# Access Compliance Report

## Public Rights-of-Way

### (Curb Ramps)

Intersection ID: 11318	Main Street: GRANDIN_RD	Cross Street: W_4TH_ST_EXT	Location: S
ADA ID: 90C3D90D17C8	Ramp Type: BlendTrans1	Initial Pass/Fail: Fail	Overall Compliance: No
		Severity Score: 1.25

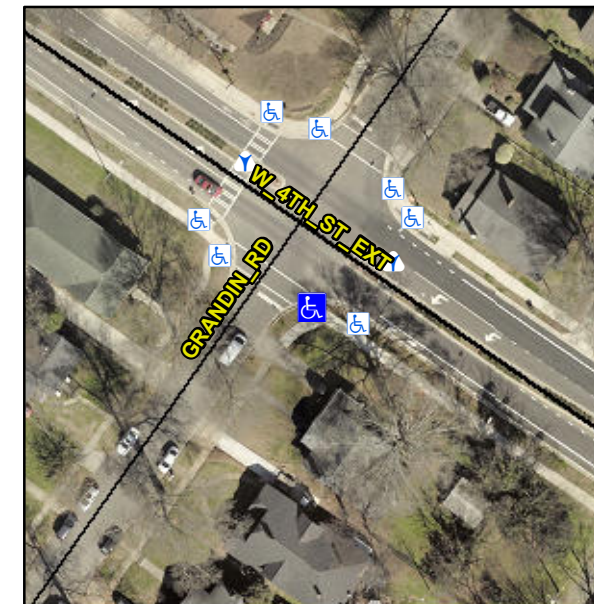
**R304.5.3**

Compliance	Description	Data	Compliance	Description	Data
N/A	Ramp Length (in)	49.0	Yes	BlendTrans Slope (%)	3.0
Yes	Ramp Width (in)	69.0	No	BlendTrans XSlope (%)	2.8
N/A	Flare Type LT	N/A	N/A	Flare Type RT	N/A
N/A	Flare Slope LT (%)	N/A	N/A	Flare Slope RT (%)	N/A
N/A	Flare Traversable LT?	N/A	N/A	Flare Traversable RT?	N/A
N/A	Landing Length (in)	N/A	N/A	DWS Provided?	N/A
N/A	Landing Width (in)	N/A	N/A	DWS Contrast?	N/A
N/A	Landing Slope (%)	N/A	N/A	DWS Length (in)	N/A
N/A	Landing X Slope (%)	N/A	N/A	DWS Full Width?	N/A
N/A	Landing Curb? (Y/N)	N/A	N/A	DWS Offset (in)	N/A
N/A	Shared Landing?	N/A			
N/A	Gutter Ponding?	N/A	N/A	Gutter Slope (%)	N/A
N/A	Gutter Lip Ht (in)	N/A	N/A	Gutter X Slope (%)	N/A
N/A	Painted X Walk1?	No	N/A	Painted X Walk2?	N/A
	X Walk 1 Direction	To NW		X Walk 2 Direction	N/A
	X Walk 1 Width (in)	N/A		X Walk 2 Width (in)	N/A
	X Walk 1 Slope (%)	2.3		X Walk 2 Slope (%)	N/A
	X Walk 1 X Slope (%)	1.8		X Walk 2 X Slope (%)	N/A

**Remove & Replace Curb Ramp With Two New Directional Ramps or Equivalent.**
